Technical Service Bulletin

SUBJECT:		No: TSB-21-51-001	
GAP BETWEEN FRONT WHEEL ARCH MOLDING AND FENDER		DATE: January 2021	
		MODEL: 2011-20 Outlander Sport	
CIRCULATE TO:	<input type="checkbox"/> GENERAL MANAGER	<input checked="" type="checkbox"/> PARTS MANAGER	<input checked="" type="checkbox"/> TECHNICIAN
<input checked="" type="checkbox"/> SERVICE ADVISOR	<input checked="" type="checkbox"/> SERVICE MANAGER	<input checked="" type="checkbox"/> WARRANTY PROCESSOR	<input type="checkbox"/> SALES MANAGER

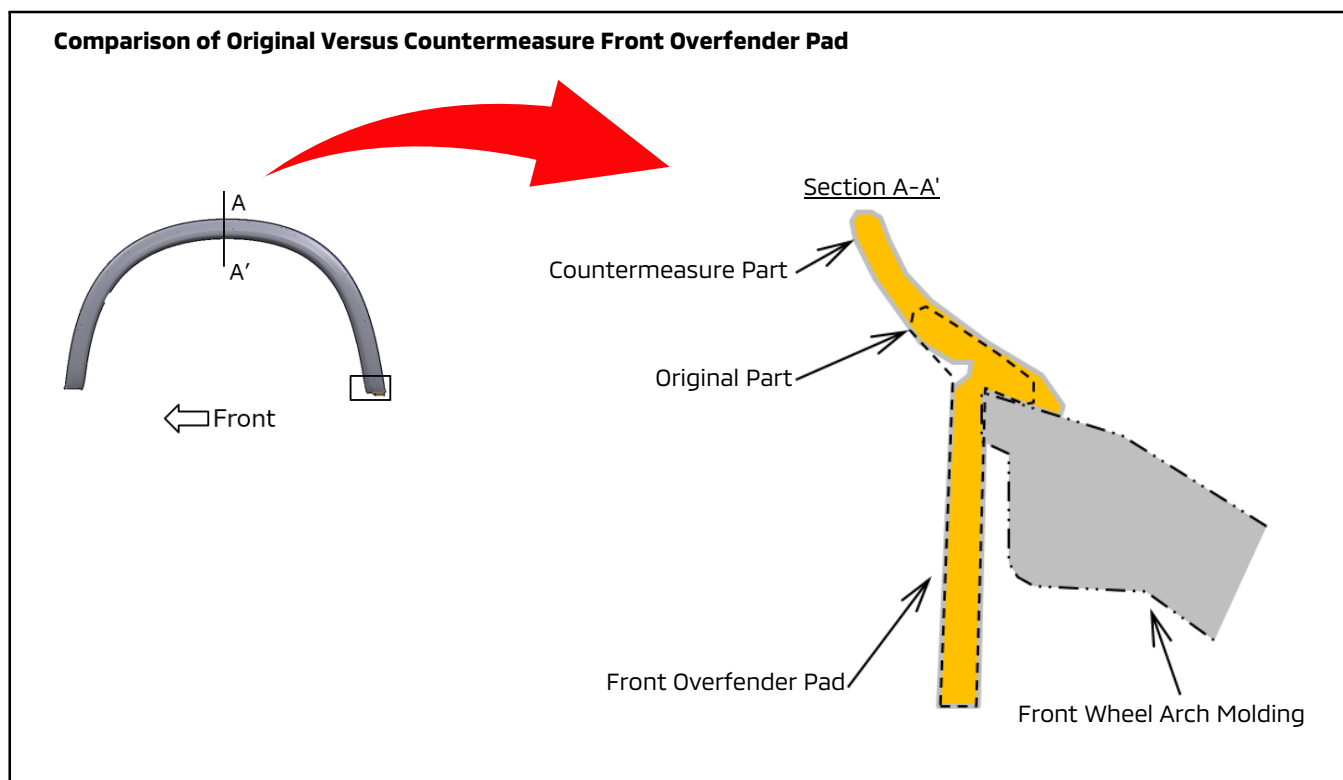
A customer may report a condition in vehicles equipped with a front wheel arch molding, where there is a gap between the front wheel arch molding and the fender. The front wheel arch molding is installed on the fender. When the position of the front wheel arch molding mounting hole is shifted, a gap may form over time.

This TSB instructs dealers to replace both sides of the wheel arch molding.

- Replace both sides at the same time. The countermeasure parts have a different front overfender pad shape than the existing parts.
- Refer to the applicable Service Manual, Group 51 Exterior, Overfender, Removal and Installation.
